APPLICATION NO.	FILING DATE	FIRST NAMED INVENTOR	ATTORNEY DOCKET NO.	CONFIRMATION NO.
10/811,050	03/29/2004	Stephen Meek	ONS00556	9523
7590	11/23/2005		EXAMINER	
Mr. Jerry Chruma Semiconductor Components Industries, L.L.C. Patent Administration Dept - MD/A700 P.O. Box 62890 Phoenix, AZ 85082-2890			ZWEIZIG, JEFFERY SHAWN	
		ART UNIT	PAPER NUMBER	
		2816		
DATE MAILED: 11/23/2005

Office Action Summary	Application No.	Applicant(s)	
	10/811,050	MEEK ET AL.	
	Examiner	Art Unit	
	Jeffrey S. Zweizig	2816

**TITLE: METHOD OF FORMING A FLOATING CHARGE PUMP
AND STRUCTURE THEREFOR**
INVENTOR: Stephen Meek et al
DOCKET NO.: ONS00556

FIG. 1 Prior Art

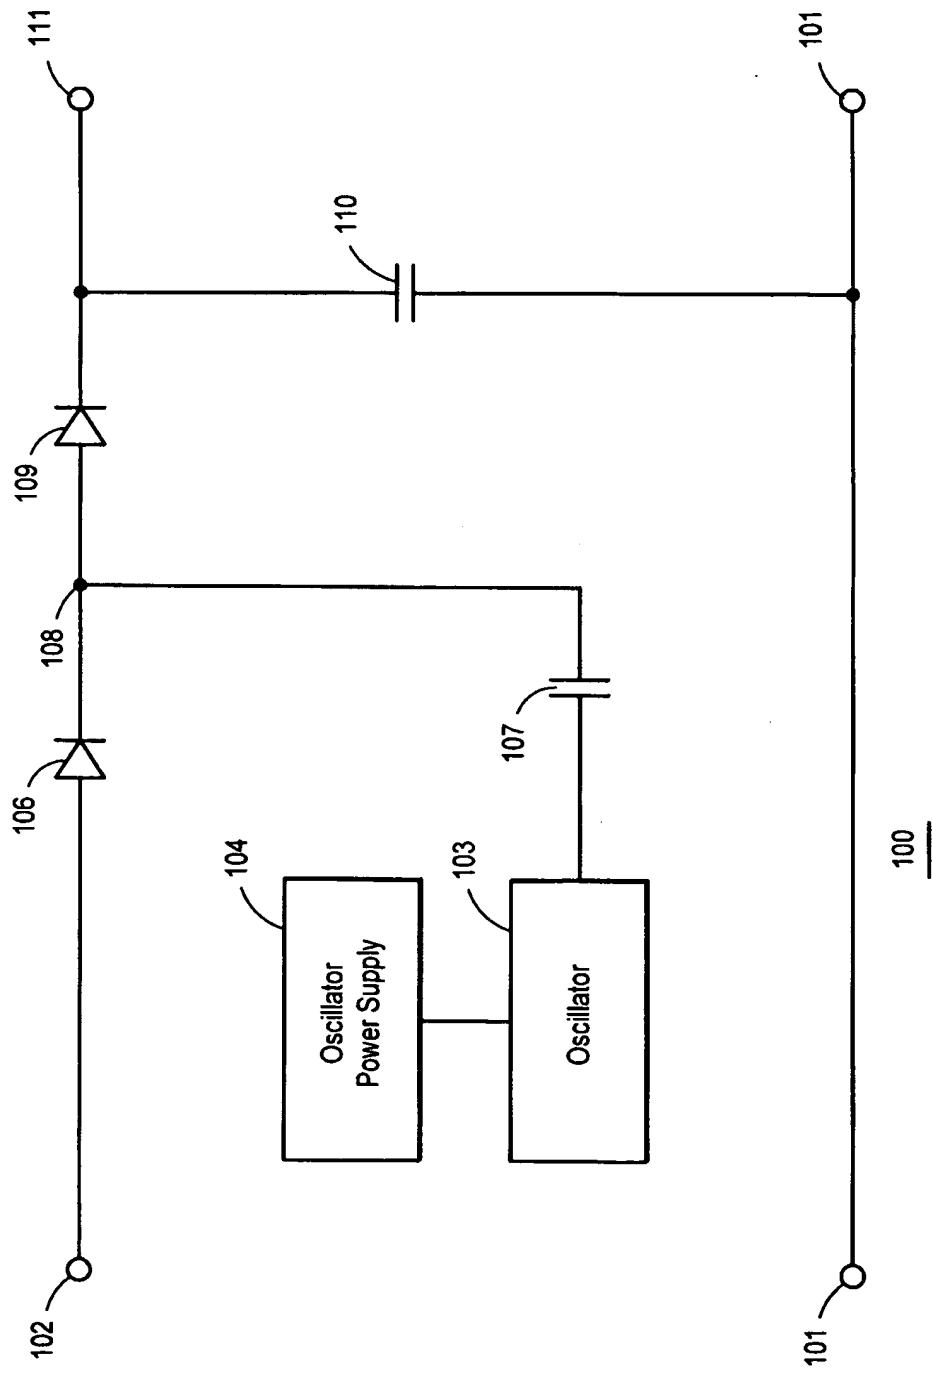
Okay
JZ
11/21/05

FIG. 2

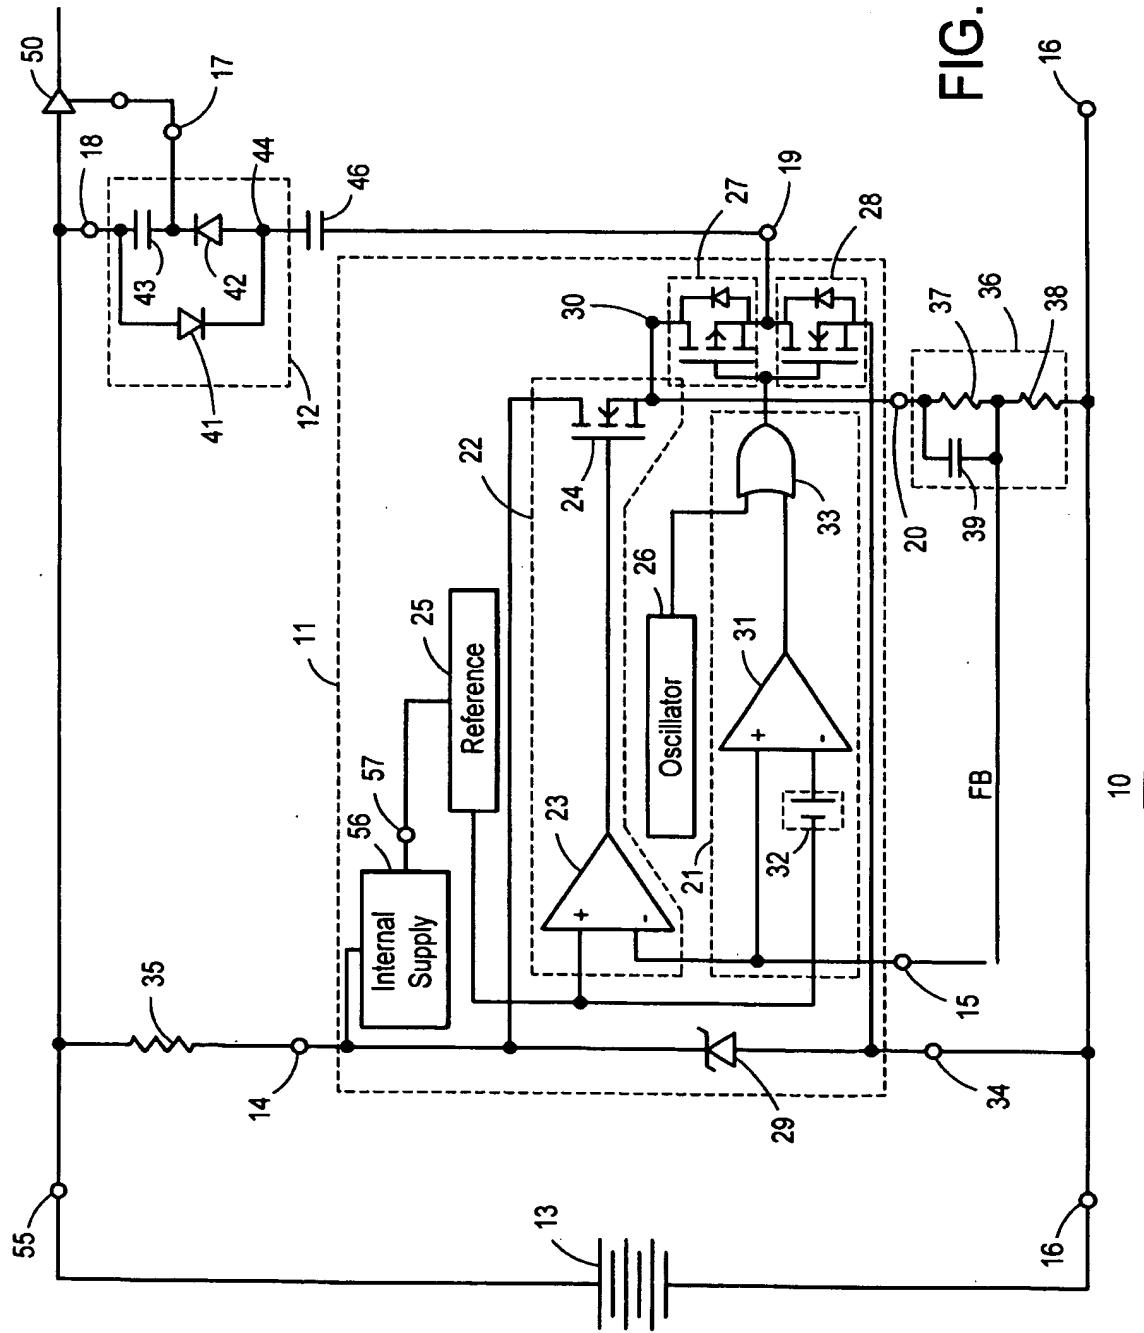
Okay
11/21/05

FIG. 3

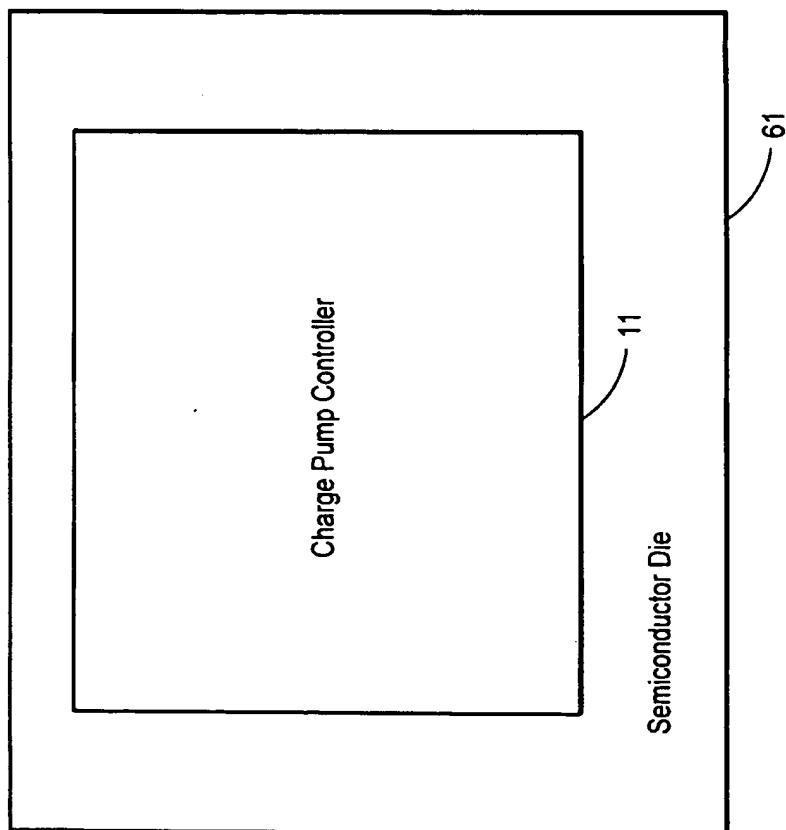
Okay
JZ
11/21/05
